**Subject:** Continuing Regulatory Violations at Sandia Mixed Waste Landfill  
**Attachments:** SecretaryFlynn.letr.5yr.FINAL.pdf; Secretary Flynn Final Figures.pdf

Citizen Action requests that you also take protective steps in accordance with hazardous waste management laws for the Sandia National Laboratories' (SNL) Mixed Waste Landfill (MWL) that has unlined pits and trenches leaking into Albuquerque's drinking water aquifer. The MWL is a nuclear weapons legacy waste site. The state of New Mexico should not bear the financial responsibility for cleanup nor the environmental consequences of no cleanup.

Figure 7. The disposal pits in the Classified Area of the SNL MWL dump.

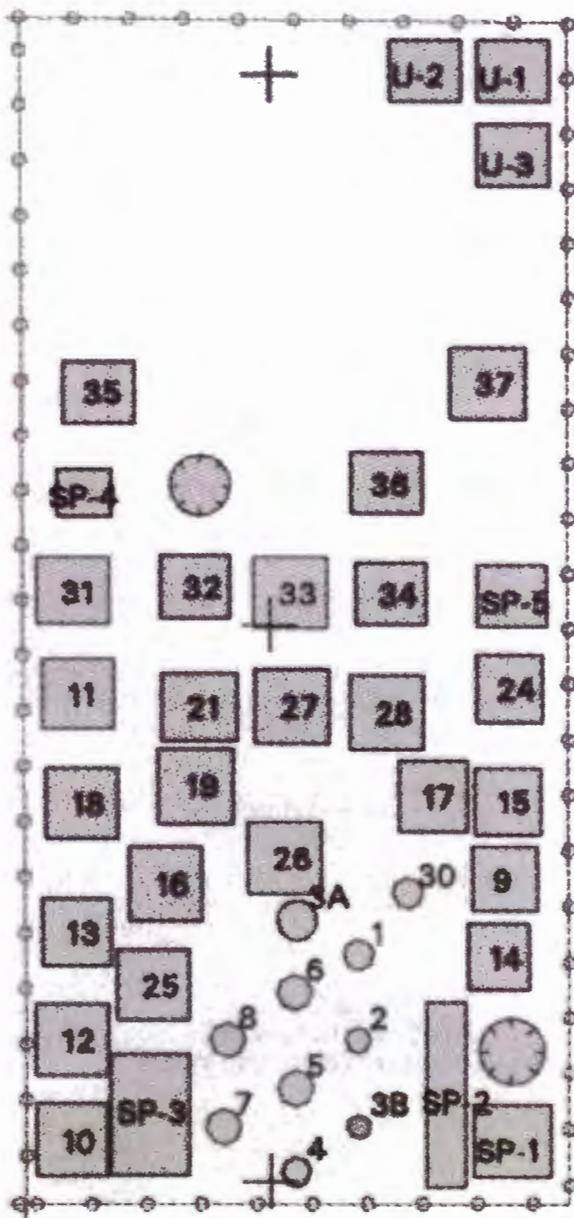
- A large and unknown quantity of liquid wastes including solvents was disposed of in pit SP-1.
- The inventory of tritium wastes in the Classified Area was > 1450 curies.
- The pits were not sealed to prevent inflows of large quantities of storm water.
- The SNL proposed MWL LTMMP does not monitor groundwater contamination from the Classified Area (See Figure 13).

**Figure 9. Location of the new defective detection monitoring wells MWL-MW7, -MW8 and -MW9 along the western boundary of the Sandia MWL Dump and new background monitoring well MWL-BW2 200 feet east of the MWL Dump.**

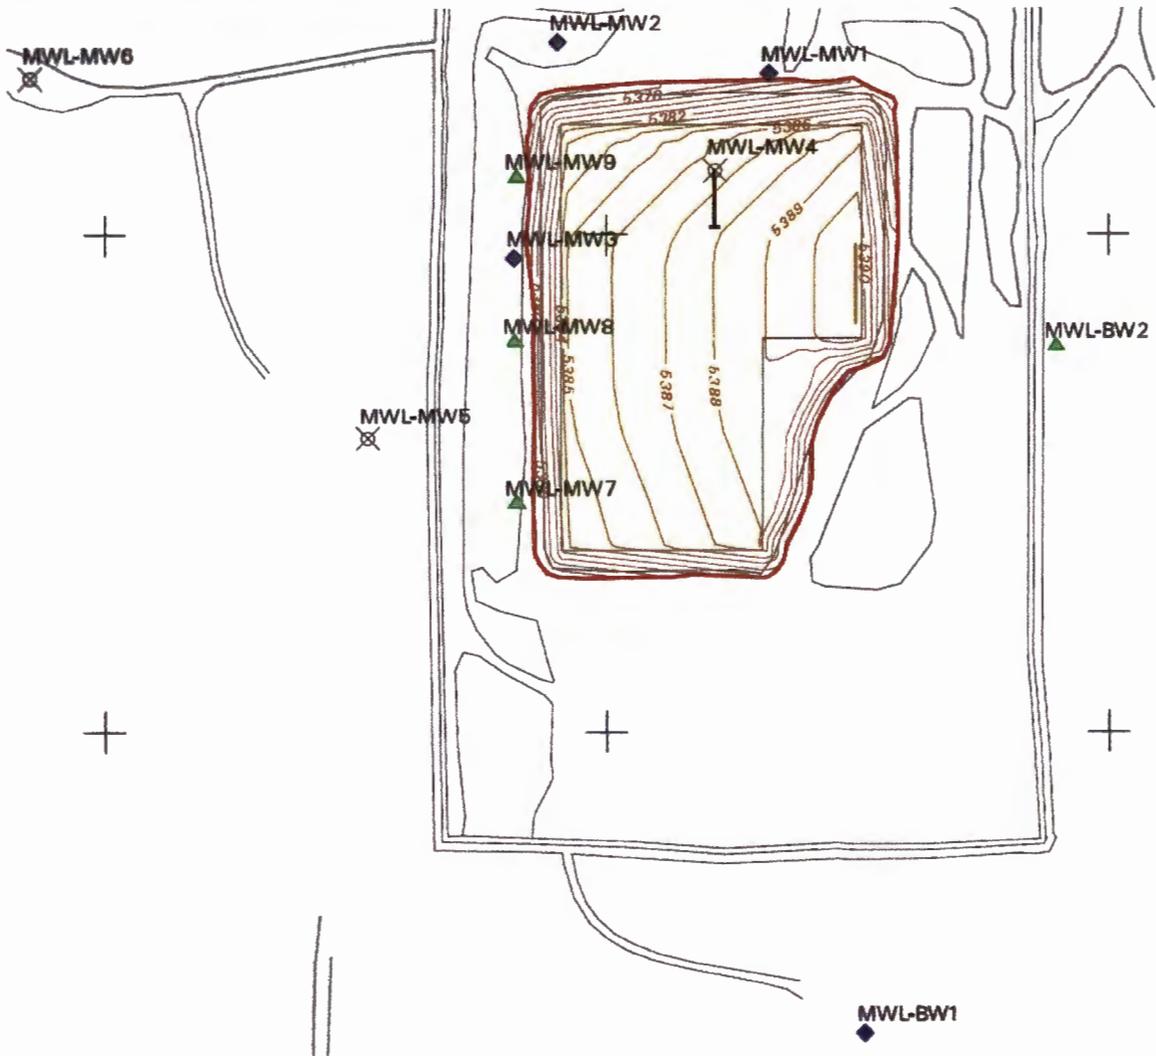
Mr. Gilkeson's current findings are that all of the six contaminant detection monitoring wells in the current network (see Figure 9) require replacement because they do not produce usable data for 1) knowledge of the direction of groundwater flow at the water table or 2) knowledge of groundwater contamination. The only reliable monitoring well in the current network is the well MWL-BW2 installed for background water quality data.

Figure 11. "Figure 3-12. Regional Water Table Map for Technical Areas 3 and 5, April 2000" in DOE/SNL Mixed Waste Landfill Groundwater Report, 1990 through 2001 by Goering et al., (2002).

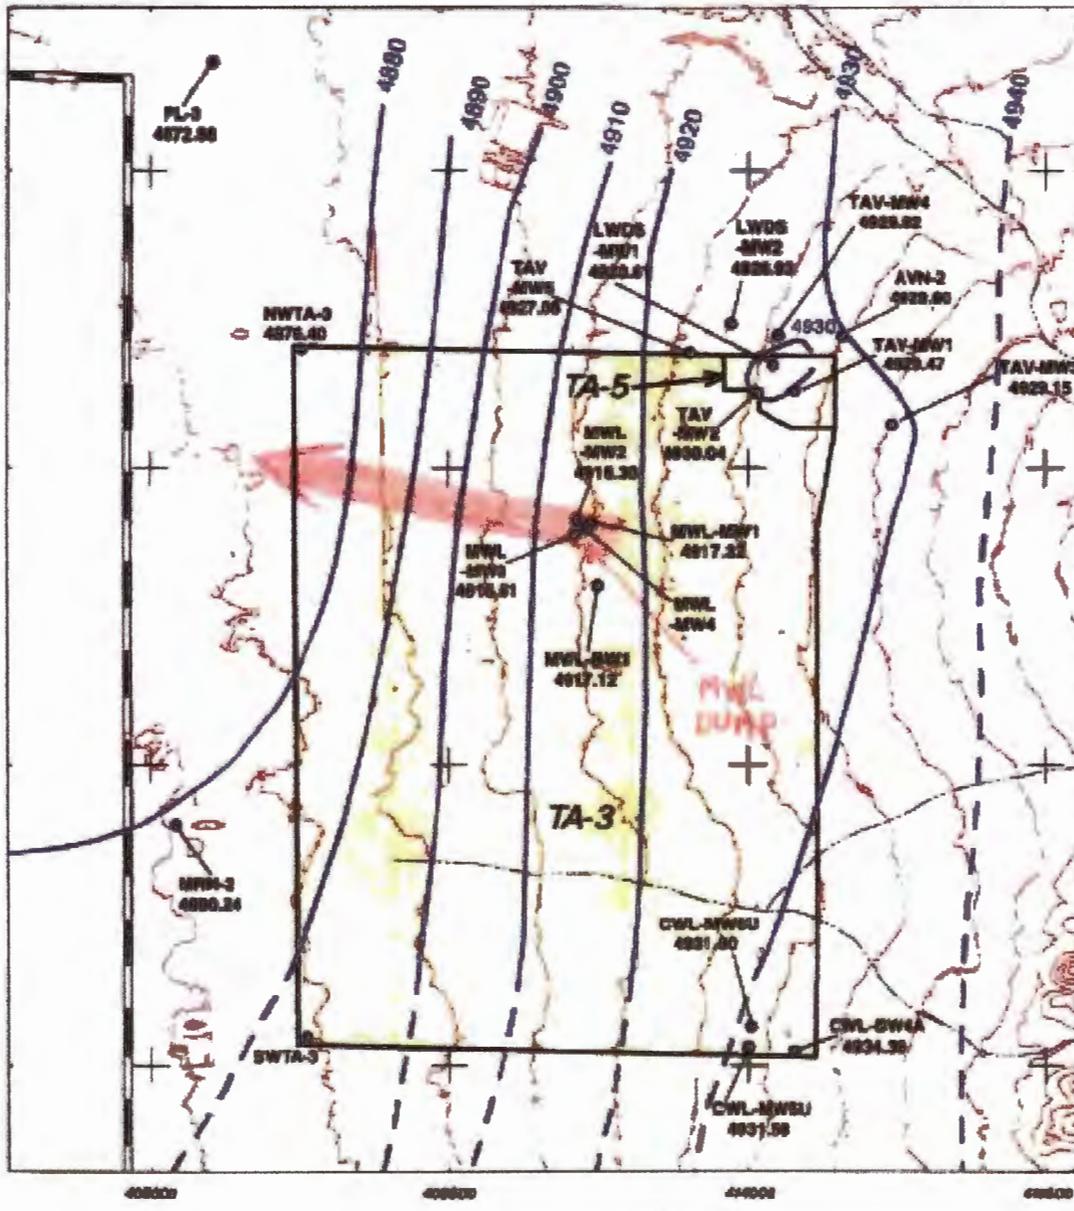
An apparent scheme by DOE/SNL to conceal the southwest direction of groundwater flow below and away from the SNL MWL dump was the “regional groundwater flow map” presented in the 2002 DOE/SNL Mixed Waste Landfill Groundwater Report, 1990 through 2001 by Goering et al. The northwest groundwater flow in the regional groundwater flow map in Goering et al., was based on water levels measured in April 2000 in wells that are located over a mile away from the MWL dump (see Figure 11).

- The red flow line shows the northwest direction of groundwater flow based on the inappropriate use of groundwater elevations measured in wells located miles away from the SNL MWL dump.
- However, the water table elevations measured in the monitoring wells located close to the MWL dump show the direction of groundwater flow below and away from the dump is to the southwest (see Figure 12).

Figure 13. "Figure 4-3. Localized Potentiometric Surface of the Basin Fill Aquifer at the Mixed Waste Landfill, October 2011" in SNL Annual Groundwater Monitoring Report Calendar Year 2011.

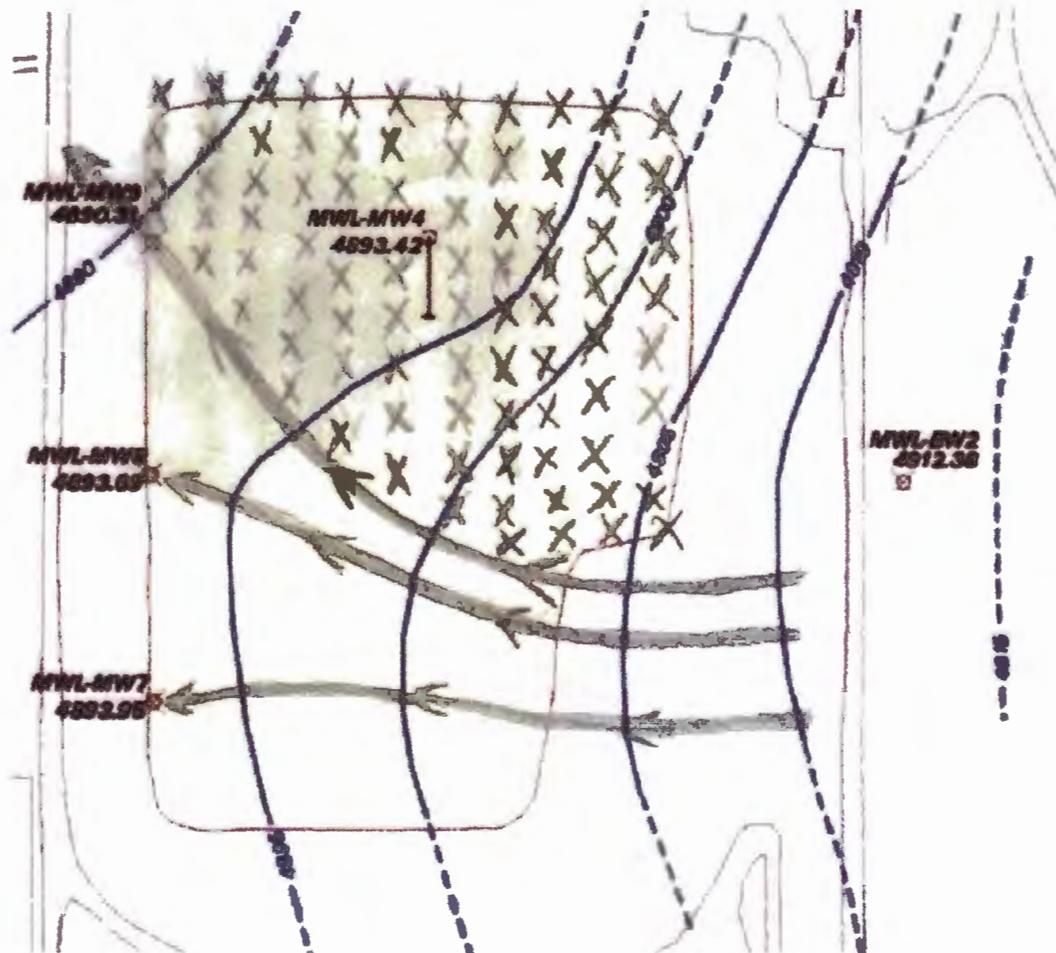
Mr. Gilkeson points out a very serious issue is that the potentiometric groundwater surface contour maps in the SNL proposed LTMMP and in the SNL 2012 Annual Groundwater Monitoring Report (see Figure 13 in this report) show a contour map for the groundwater flow direction below the SNL MWL dump as being toward the north-northwest. The contour map is not based on the elevation of the water table at the MWL. The contour map in Figure 13 is contrary to the knowledge from the early 1990s to 2008 for the flow of groundwater being to the south-southwest.

However, if the groundwater flow map in the DOE/SNL proposed LTMMP is accepted as accurate, then a large part of the SNL MWL dump is not monitored for contamination to groundwater. This fact is illustrated by the groundwater flow lines drawn on the flow map in Figure 13. For example, Figure 13 shows that groundwater contamination from the Classified Area of the MWL dump is not monitored by the existing network of contaminant detection monitoring wells that include wells MWL-MW7, -MW8 and -MW9 located along the west side of the MWL dump.

The arrowed lines show the direction of groundwater flow for the groundwater piezometric surface map in the SNL MWL dump proposed Long Term Monitoring and Maintenance Plan (LTMMP).

The large region marked with X's shows that the SNL MWL proposed LTMMP does not have any monitoring wells at appropriate locations to detect groundwater contamination from the northern region of the SNL MWL dump.

The Classified Area of the SNL MWL dump (see Figures 2 and 7) is not monitored for groundwater contamination. The NMED August 11, 2004 MWL Fact Sheet states that "The classified area contains wastes that in all likelihood present the greatest security, worker safety, and environmental concerns. Wastes in the classified area include military hardware, radioactive constituents (e.g., cobalt-60, cesium-137, tritium, radium-226), activation products (e.g., cobalt-60), multiple fission products (e.g., cesium-137, strontium-90), high specific-activity wastes (e.g., tritium, cobalt-60), plutonium, thorium, and depleted uranium."
